NORTHEASTERN CONNECTICUT COUNCIL OF GOVERNMENTS

ENGINEERING PLAN REVIEW

3-LOT SUBDIVISION

CHURCH STREET

Sheet No. 1 OF 4 Project No. 1895 Date: April 10, 2021

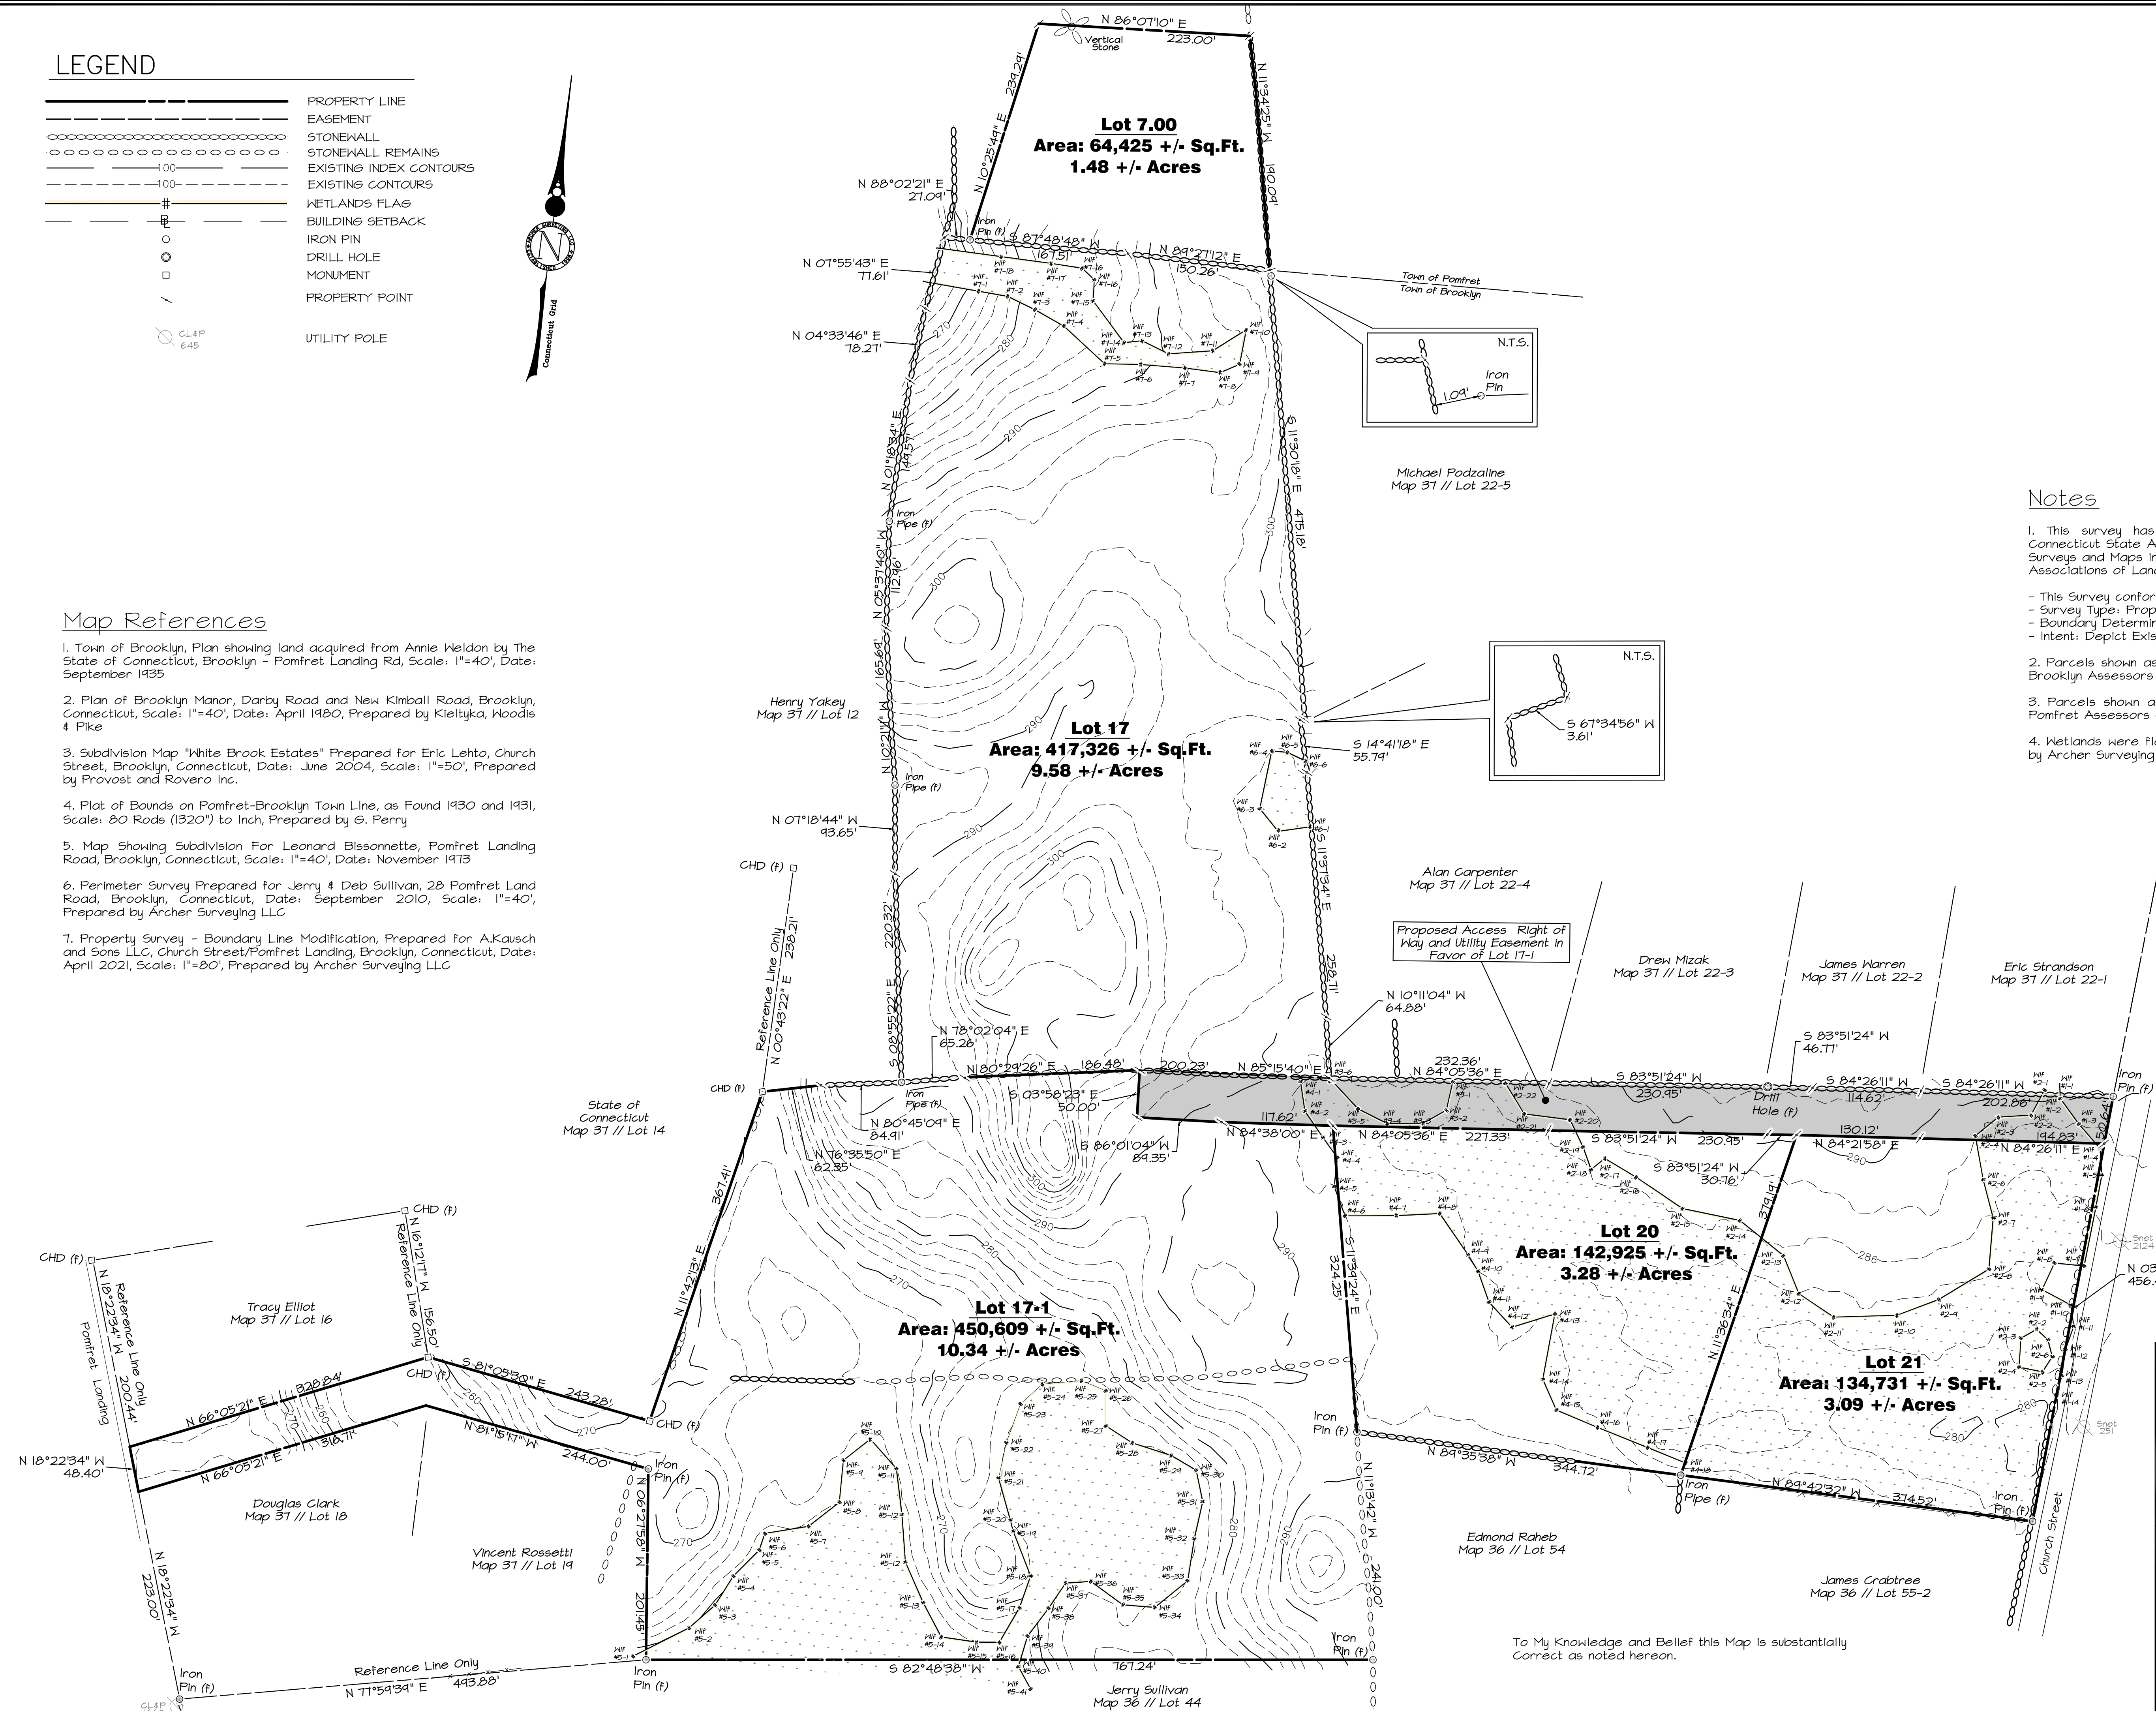
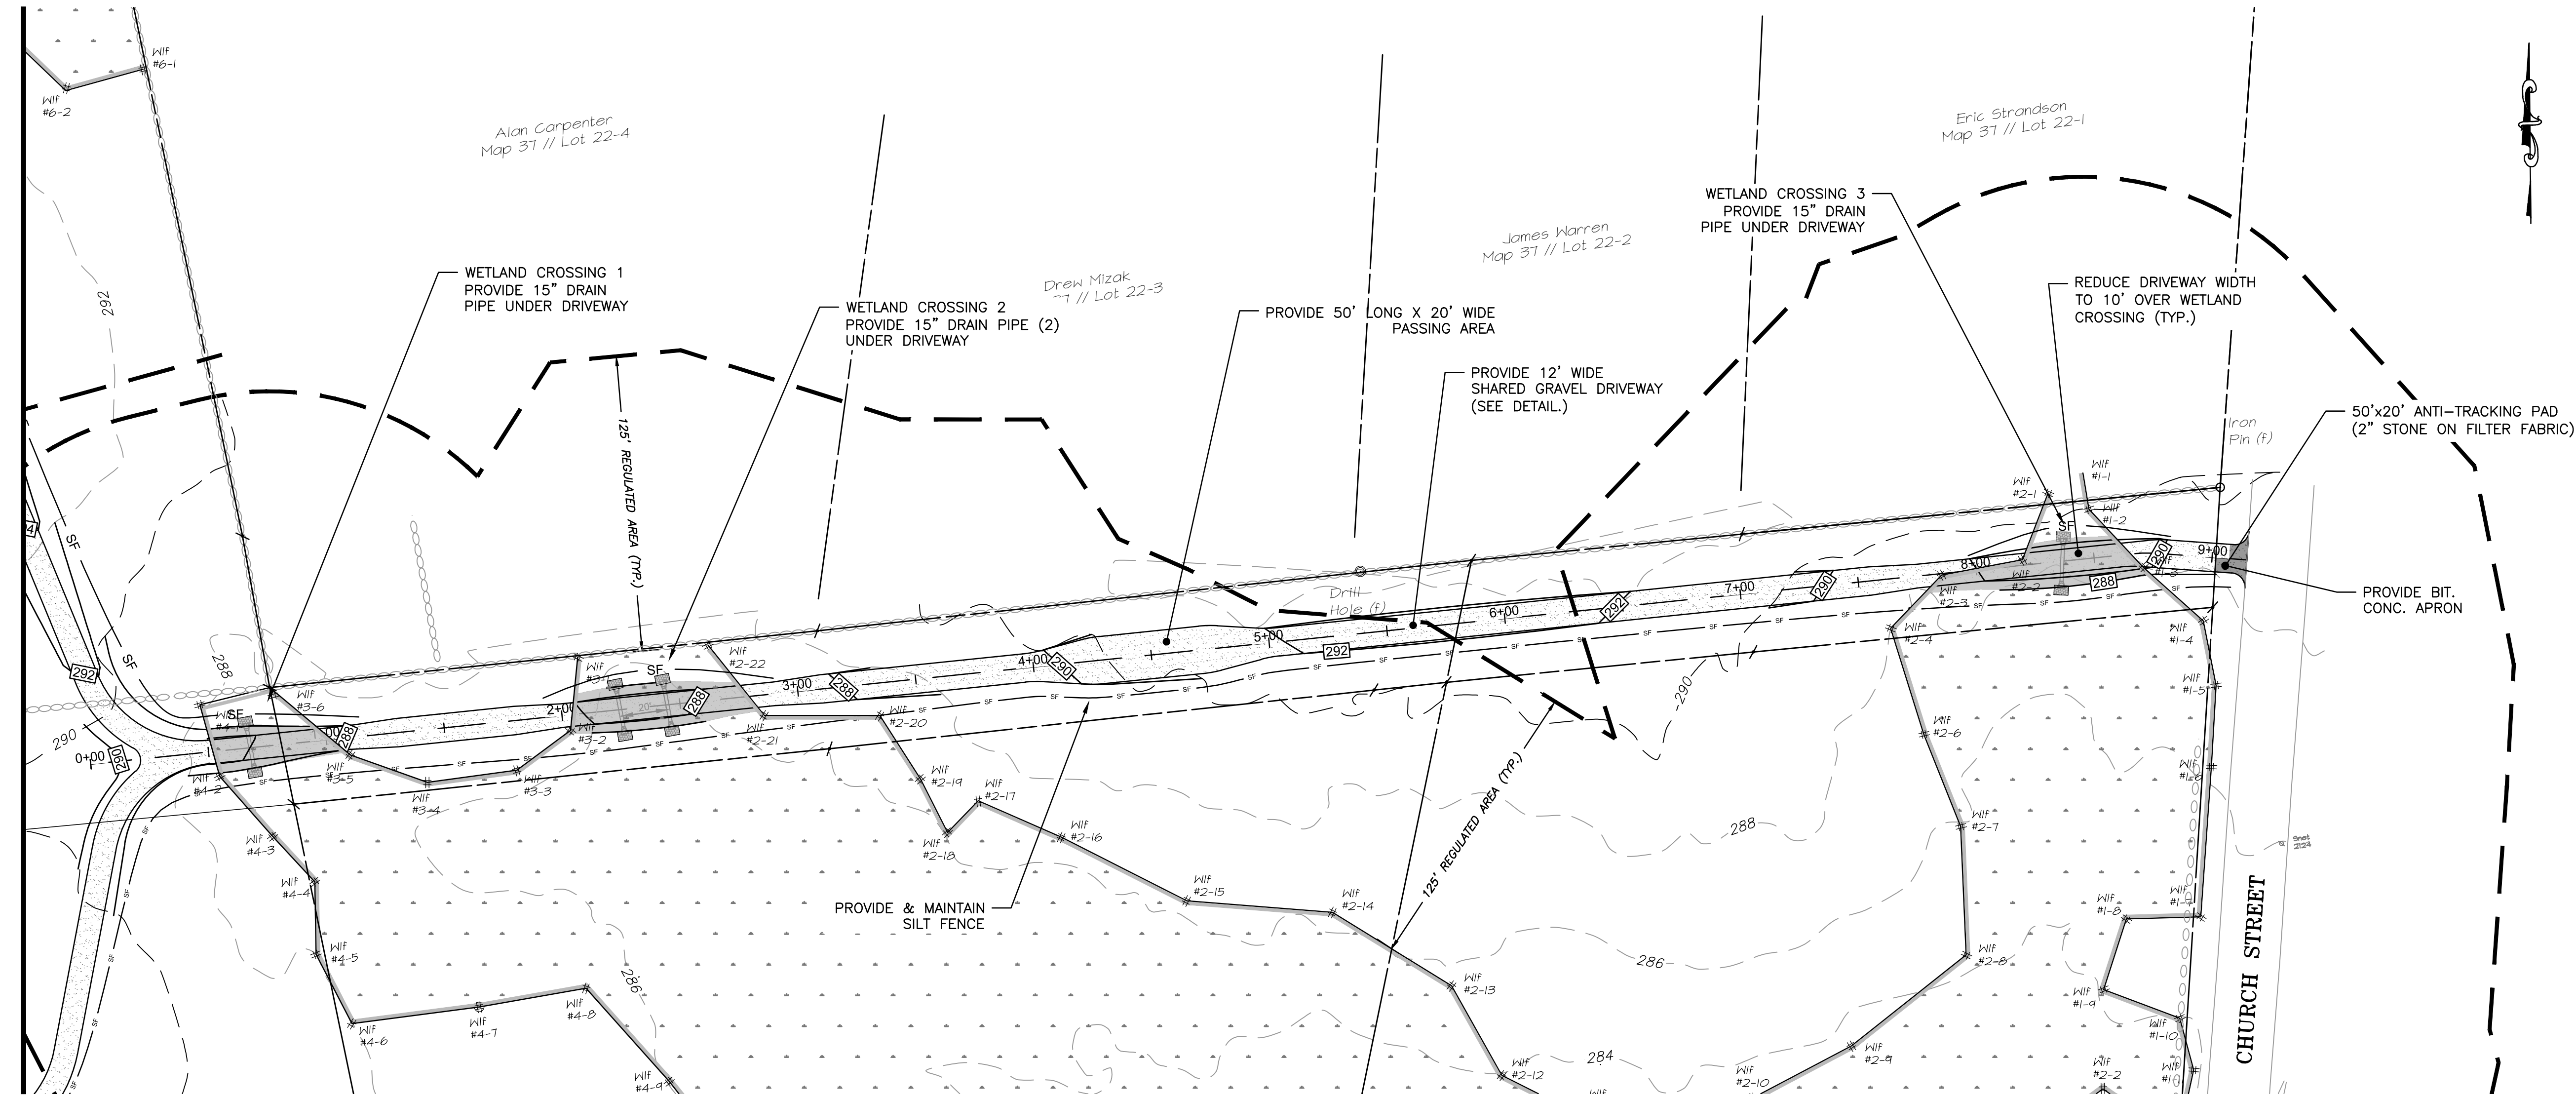
Sheet 1 of 4 – Property Survey Plan

1. Location Map is missing a north arrow.
2. Note 1 under “Notes” does not include the accuracy of the topographic elevations shown on the plan. The accuracy needs to be included as part of this note.
3. Zoning criteria is missing on this plan.
4. A “property line symbol” covers some stone wall symbols but not others in the lots of interest. Why is this so?
5. Wetland delineation certification block and signature of the certified Connecticut soil scientist is missing on the plan.
6. A silt fence, compost/silt sock and/or hay bale sediment control symbol needs to be included in the “Legend.”

| <p>CLA Engineers, Inc. CIVIL • STRUCTURAL • SURVEYING</p> <p>317 Main Street Norwich, CT 06360 (860) 886-1966 Fax (860) 886-9165</p> | | | <p>Project No. CLA-6639</p> <p>Proj. Engineer R.A.D.</p> <p>Date: 04/30/21</p> <p>Sheet No. 2 of 4</p> |

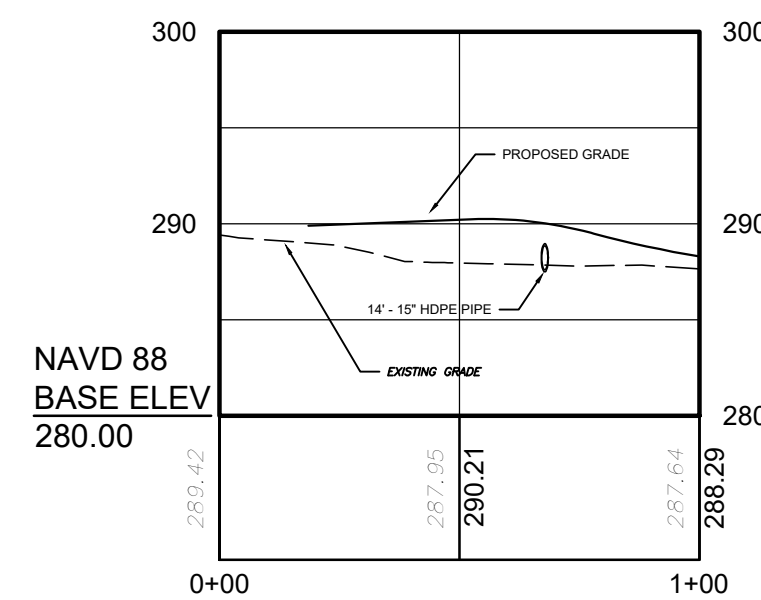
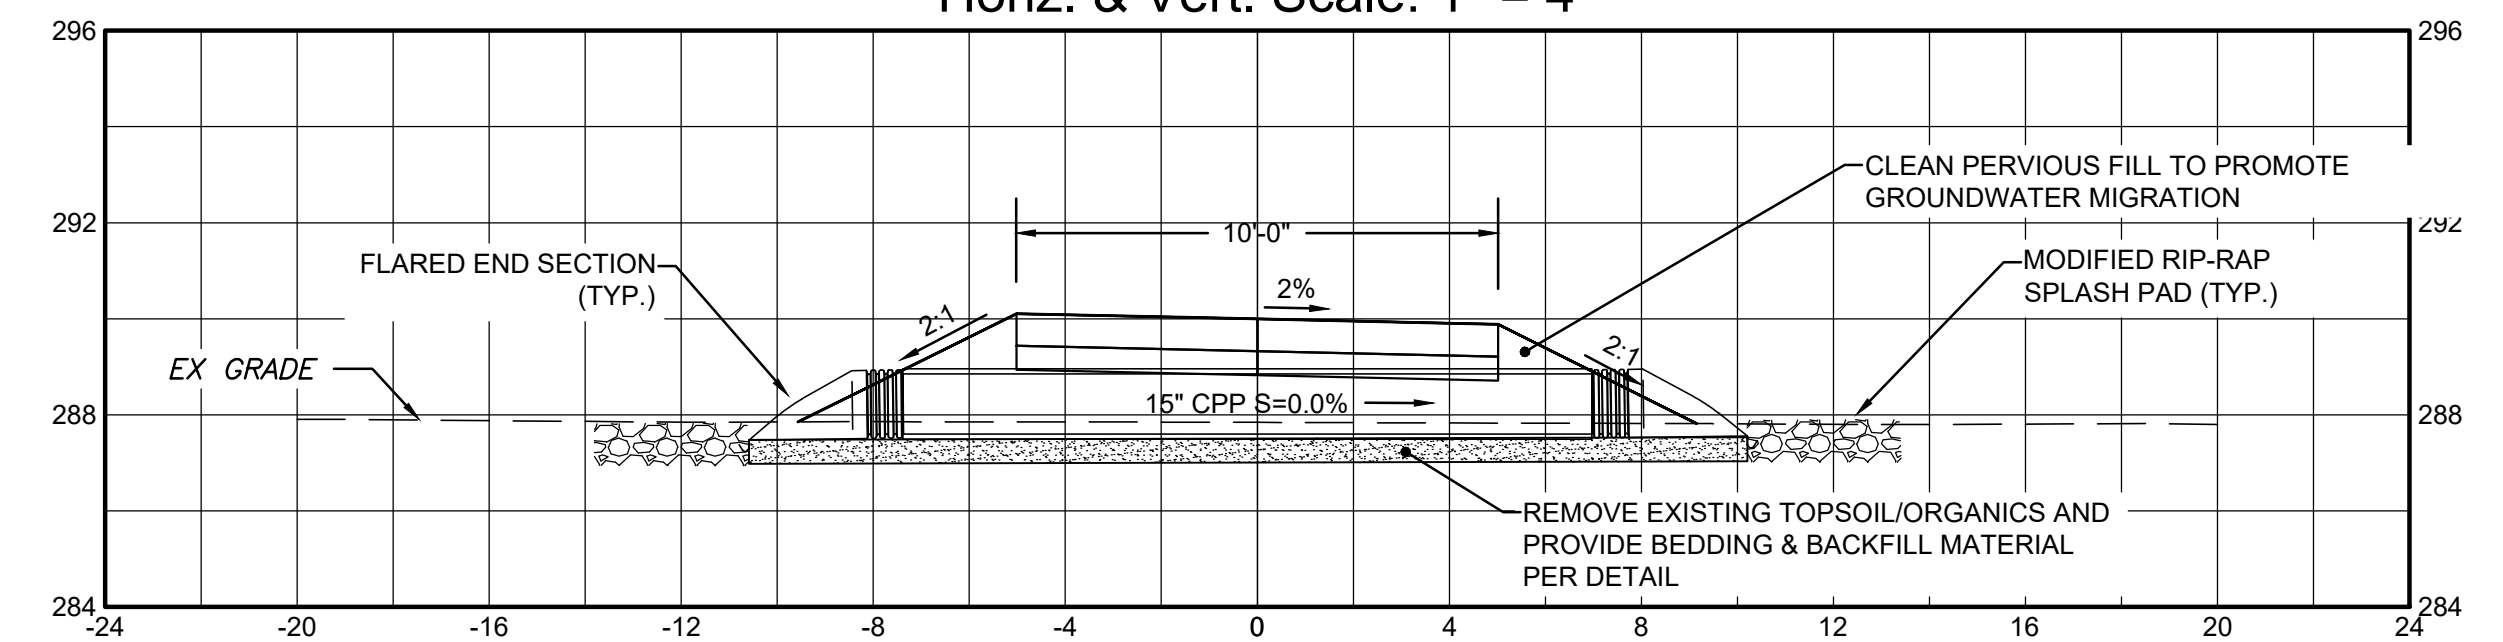
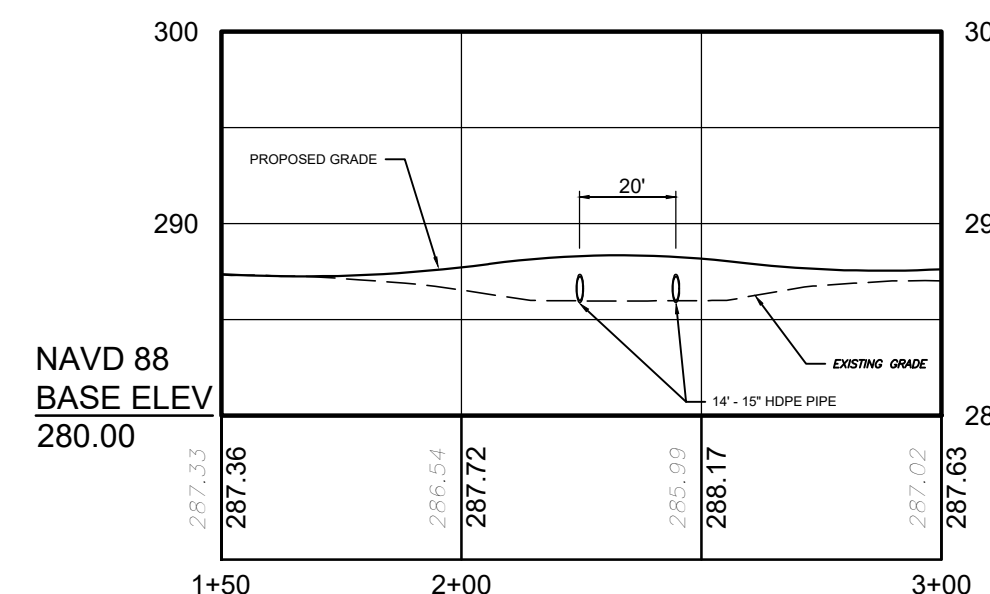
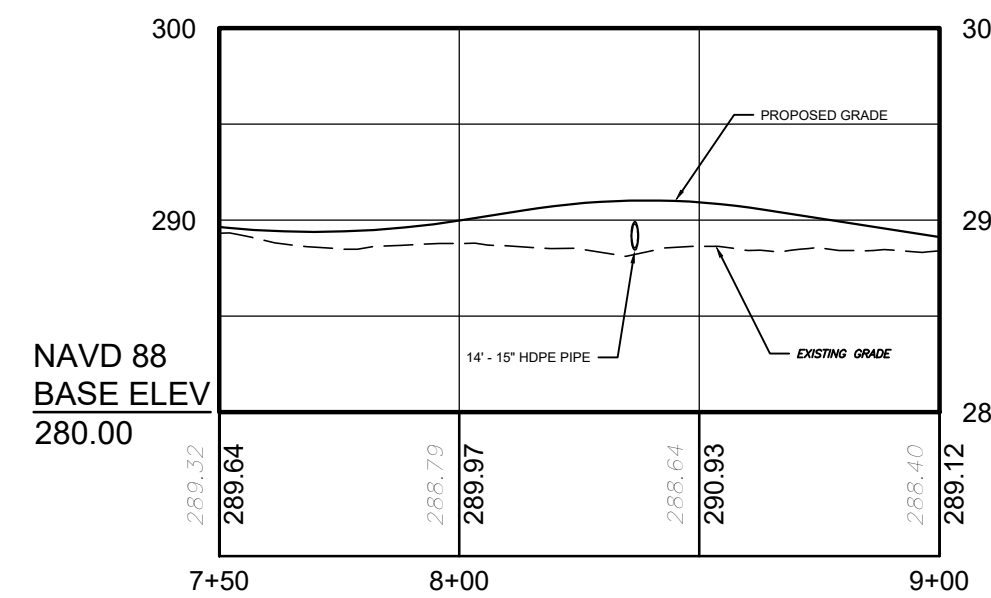
Sheets 2 & 3 of 4 – Grading & Site Design Plan

1. The area of disturbed wetlands is not noted on the plan (driveway crossing and underground utilities installation). The areas of disturbance need to be noted on the plan.
2. Underground utilities will disturb wetlands. The route of the utilities should be shown on the plan.

3. Different symbols are used for "Silt Fence." Use one symbol only and make changes to the plan to reflect this.
4. The drainage report for this project was also reviewed. It states that Wetlands Crossing 2 needs three (3) 15" pipes. The site plan and wetland crossing profile only show two (2) pipes. Therefore, an additional pipe needs to be added to the plan and profile along with distances to be maintained between the pipes.

5. Due to the proposed driveway being finished so close to the level of the wetlands, soil test pits should be dug to look for presence of groundwater and mottling, especially within the wetland crossings, to further validate the driveway cross section design depicted on Sheet 4 of 4.

6. Different symbols are used for "Silt Fence." Use one symbol only and make changes to the plan to reflect this.
7. Different symbols are used for "New Property Line." Use one symbol only and make changes to the plan to reflect this.
